RESPONSE TO SUBMISSIONS REPORT

The New Primary School in Mulgoa Rise - SSD-11070211

17 November 2021

Figure 18 – Bus Bays at Darug Avenue

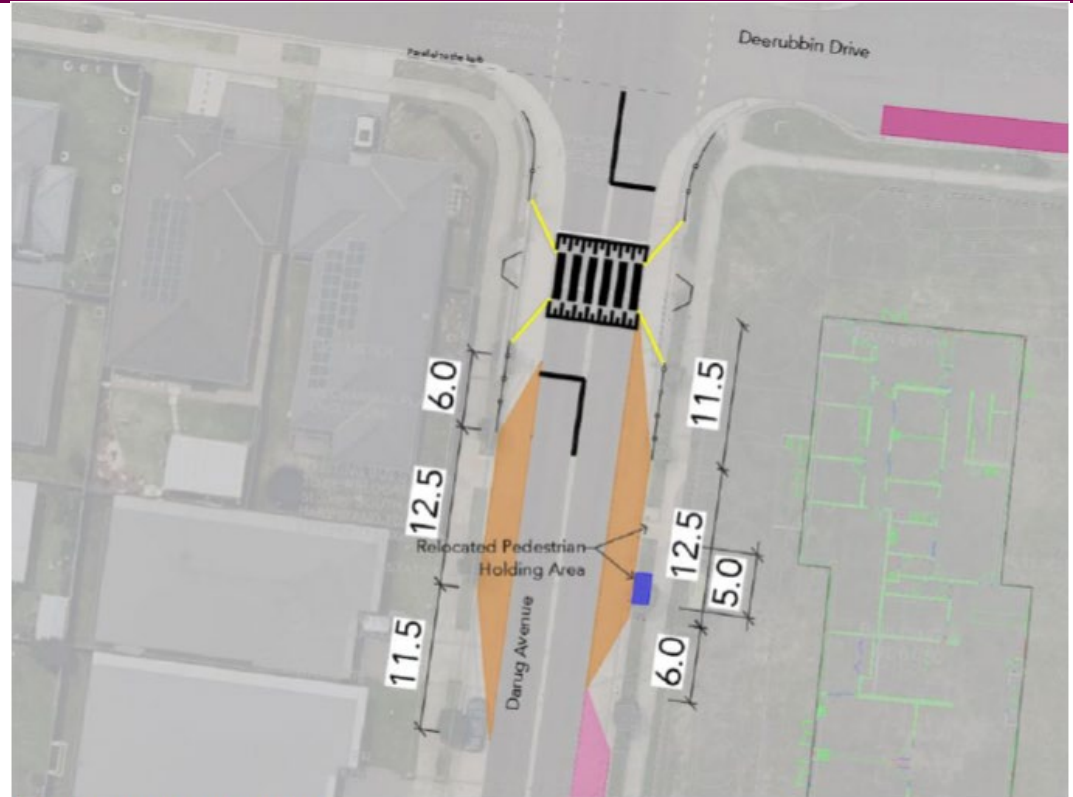
Comment/Issue	Response																									
Transport and Traffic Assessment																										
<p>a. 5.2.4.1 & Attachment 2 (Pedestrian Crossings) – Bus Bays need to be located sufficiently away from the crossing to ensure sight lines are not obstructed in line with Australian Standards (this also needs to consider how many buses may simultaneously be present, especially at bus stop B); In addition the bus bay is to have sufficient length (consider draw-in length, draw-out length, and maximum number of services expected at any one time) to ensure that buses can be fully contained within bus bay;</p>	<p>Refer to Table 4 on the preceding pages for pedestrian crossing sight lines and location of bus bays.</p> <p>The existing bus stops on Darug Avenue is currently being serviced by only one bus (794 bus service). The frequency of the bus service in both bus stops is 27-73 minutes during the school peak hours. As the existing bus frequency is very low, the existing bus stops are likely to accommodate additional bus services if the timetables are managed by departure / arrival times. According to TfNSW Guidelines for the Planning of Bus Layover Parking, a standard bus requires a minimum of 12.5m long parking length and additional 11.5m draw-in and 6.0m draw-out length, refer to the table below.</p>

<p>The proposed zebra crossing and the proposed relocated eastern bus bay have been located such that both bus bays at Darug Avenue will be compliant with the TfNSW requirement, thus will meet the minimum requirement for parking, draw-in and draw-out lengths, as shown in the figure below.</p>	Minimum Bus Draw In and Draw Out Lengths					Type of bus	Length (metres)	Min. draw-in length (metres)	Min. draw-out length (metres)	Length for one bus (metres)	Standard (inc double decker)	12.5	11.5	6.0	30.0	Long Rigid	14.5	14.0	6.5	35.0	Articulated	18.0	14.0	8.0	40.0
Minimum Bus Draw In and Draw Out Lengths																										
Type of bus	Length (metres)	Min. draw-in length (metres)	Min. draw-out length (metres)	Length for one bus (metres)																						
Standard (inc double decker)	12.5	11.5	6.0	30.0																						
Long Rigid	14.5	14.0	6.5	35.0																						
Articulated	18.0	14.0	8.0	40.0

Figure 19 – HRV Swept Path at proposed Zebra Crossing at Forestwood Drive

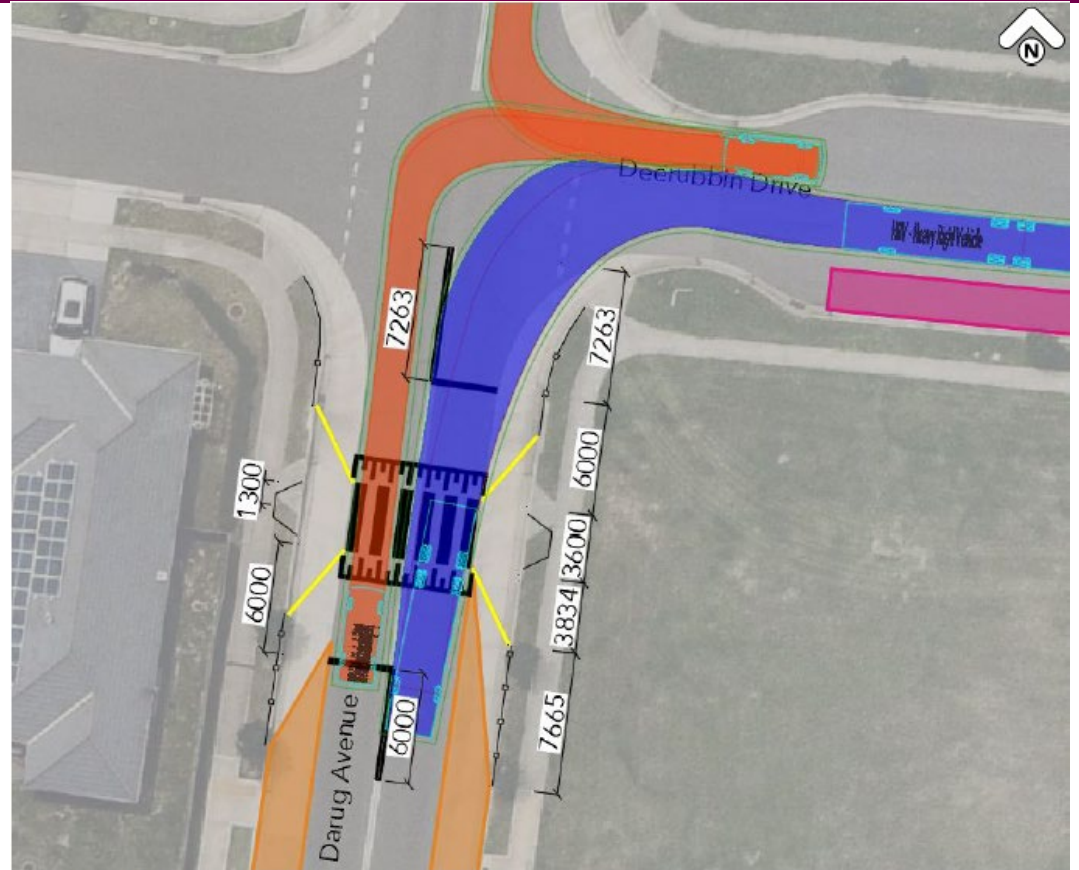
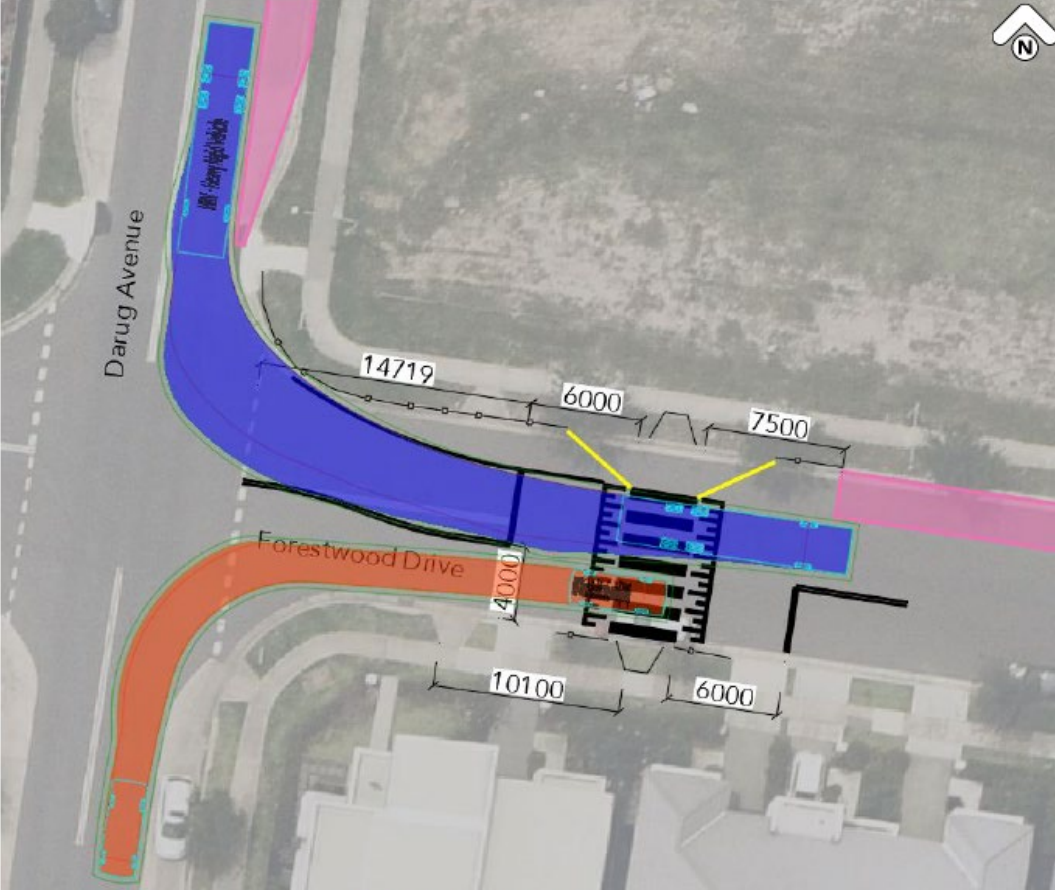
<p>i. Figure 56 & Attachment 2 (Pedestrian Crossings) – The swept path is considered unacceptable (particularly due to the proximity to the pedestrian crossing), the plans indicate that a HRV encroaches over the centreline into the opposing traffic lane on both Darug Avenue and Forestwood Drive. This would result in a B99 vehicle travelling along Forestwood Drive to be forced to occupy the very left of the carriageway which is unrealistic if the vehicle is wishing to travel straight or turn right (and arrives before the HRV);</p>	<p>The proposed zebra crossing at Darug Avenue has been relocated further south and is located at 13.3m south of Darug Avenue / Deerubbin Drive intersection. The HRV turn movement swept path has been re-run and it can be accommodated without crossing the opposite lane, as shown in Figure 19.</p> <p>The proposed zebra crossing location at Forestwood Drive has been relocated further east at 20.7m from the Darug Avenue / Forestwood Drive intersection. The proposed new location allows for adequate turn movement as shown in Figure 20.</p> <p>In any case, it is noted that local roads seldomly allow for an HRV movement without crossing into the opposite lane. Further, the turn movements discussed above are not likely to occur during the pick-up and drop-off time, as no bus routes run along these routes and waste collection will occur outside of pick-up and drop-off times.</p> <p>This has been agreed during the TWG meeting held on the 3rd November 2021.</p>
